MONTGOMERY COUNTY PLANNING DEPARTMENT
THE MARYLAND-NATIONAL CAPITAL PARK AND PLANNING COMMISSION

MCPB
Item #8
July 7, 2011

DISCUSSION: Bradley Boulevard Improvements Project
From Glenbrook Road to Wilson Lane
Phase I Facility Planning Study
Project Prospectus Recommendations

APPLICANT: Montgomery County Department of Transportation

Figure 1: Cross Section for Recommended Alternative (4A)

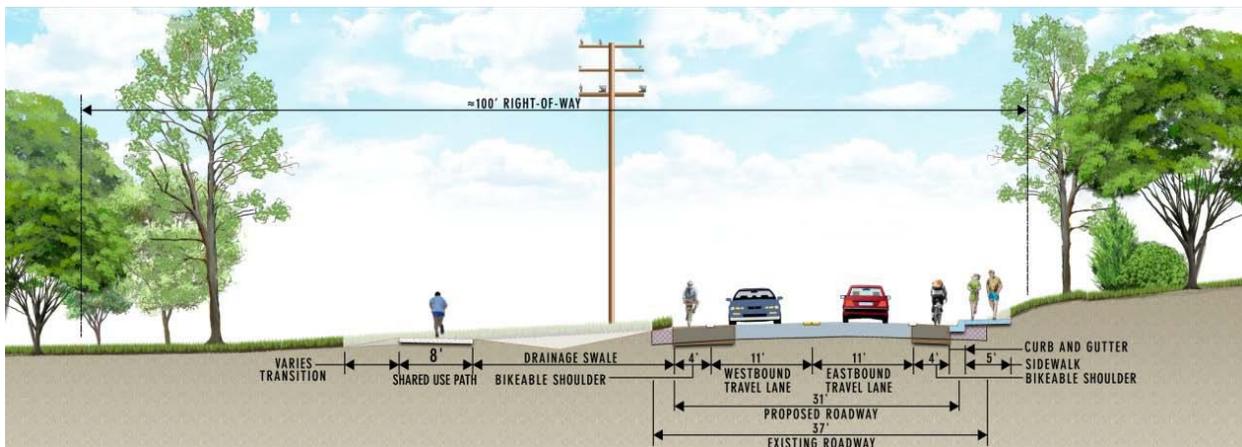
2. Provide a 6 ft buffer (min.) between the sidewalk and the curb on the south side of Bradley Boulevard by shifting the roadway to the north where right-of-way is available.

Landscaped Buffer: To the extent possible, a minimum 6 ft buffer should be provided between the sidewalk and the curb on the south side of Bradley Boulevard by shifting the roadway to the north where right-of-way is available. This will accommodate street trees and improve pedestrian comfort. A six-foot-wide buffer is also the minimum needed to avoid adjusting the sidewalk vertically or horizontally at every ADA ramp and driveway, which would make travel for disabled persons more difficult.

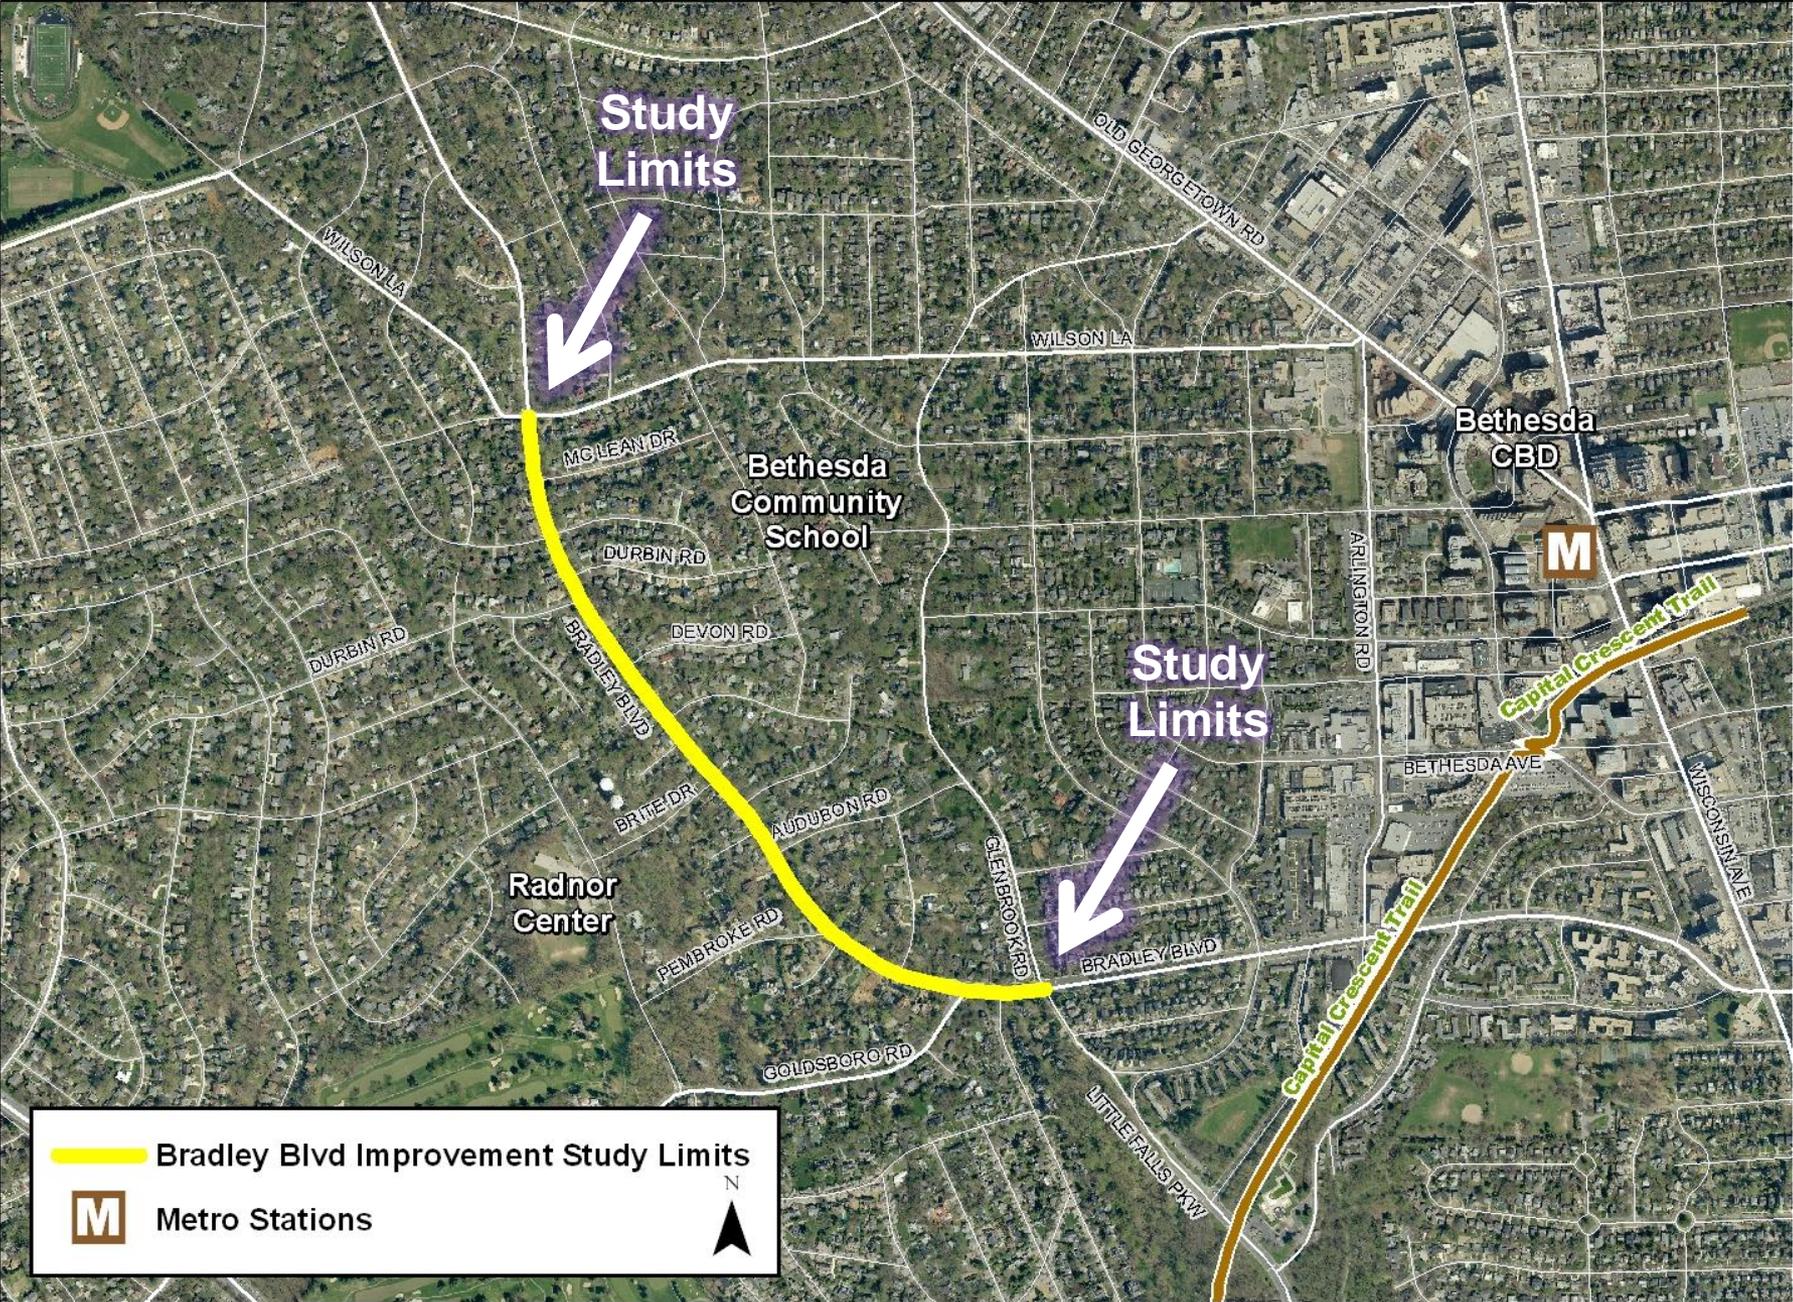
- Setback of shared-use paths at intersections: The shared-use path should cross minor streets closer to Bradley Boulevard, so that motorists turning off of Bradley Boulevard are better able to detect bicyclists. This is particularly important at the intersections with Oldchester Road and Burling Road where the shared use path is set back from the road by over 30 ft to accommodate the proposed stormwater management bioswales.
